United States Patent and Trademark Office

APPLICATION NO.	FILING DATE	FIRST NAMED INVENTOR	ATTORNEY DOCKET NO.	CONFIRMATION NO.
10/820,186	04/07/2004	Thomas R. Marsh	9066-23DV	7421
20792 75	590 11/29/2005		EXAMINER	
MYERS BIGEL SIBLEY & SAJOVEC			LUGO, CARLOS	
PO BOX 37428				
RALEIGH, NC 27627			ART UNIT	PAPER NUMBER
			3676	
			DATE MAILED: 11/29/2005

DETAILED ACTION

1. This Office Action is in response to applicant's RCE filed on November 7, 2005.

ATTACHMENT #1

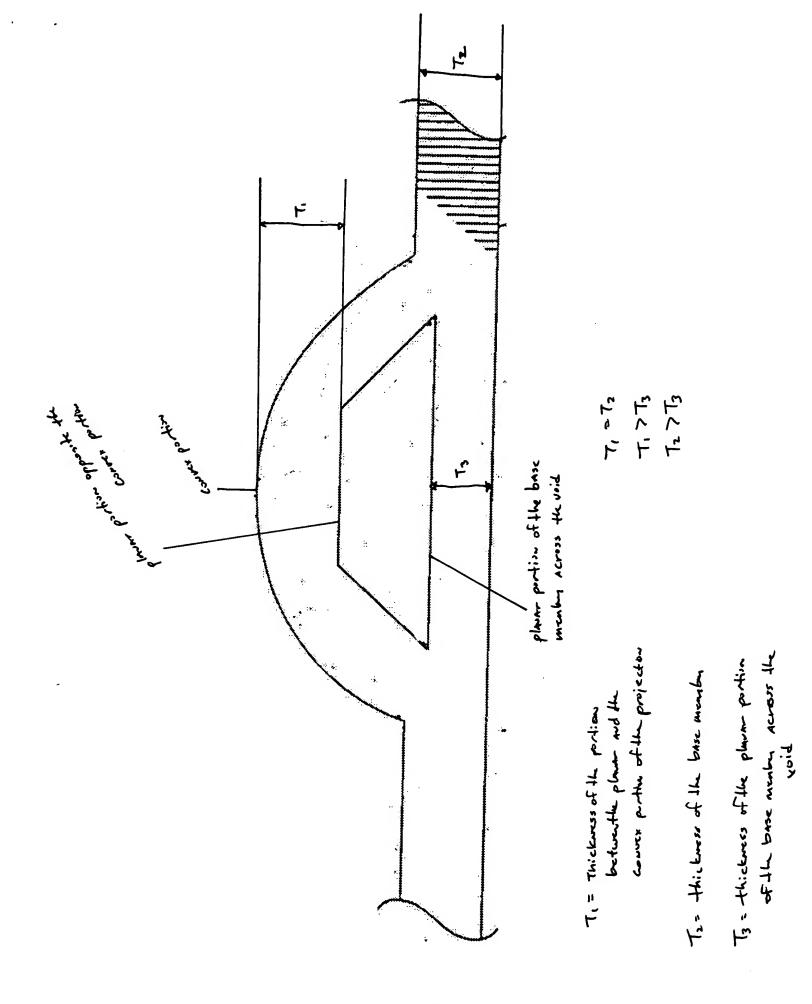
However, as seen in Figure 1, the thickness between the planar and the convex

portion of the projection is the same as the thickness of the base member. The only

different in thickness is between the thickness of the base member and the planar

portion of the base member across the void or the thickness between the planar and

the convex portion of the projection and the planar portion of the base member

across the void (see attachment #1).

Therefore, in order to continue with the examination, the limitation will be

examined as the planar portion of the base member across the void has a thickness

that is less than the thickness of the base member. Appropriate correction and/or

explanation is required.

Attachment # 2

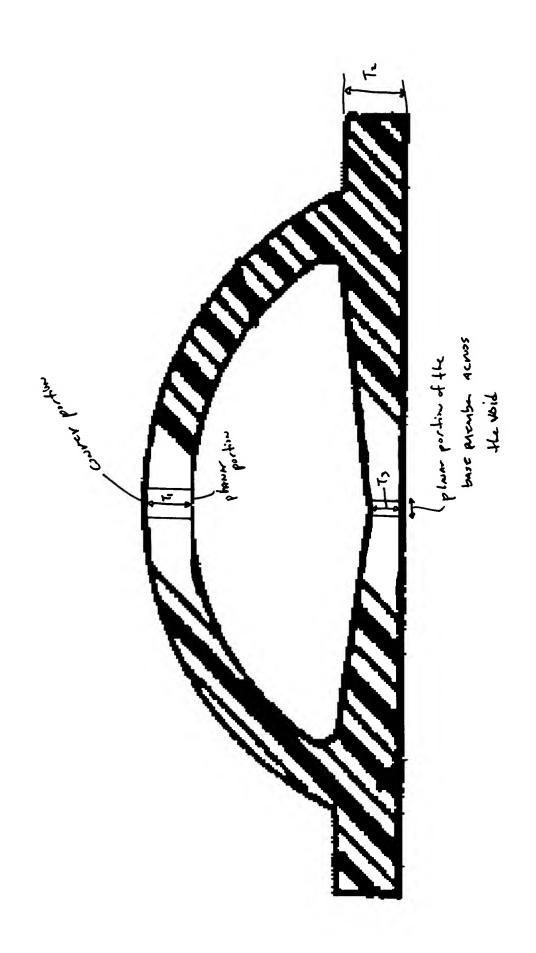
McEvoy discloses a device comprising a base member (27 and 28) having opposite first and second faces and a cushioning projection (25) extending outwardly from the second face of the base member and covering and defining a void within the

base member. The projection has a planar portion opposite the convex portion and the base member has a planar portion opposite the convex portion across the void (see attachment #2). The planar portion of the base member across the void has a thickness less than the thickness of the base member.
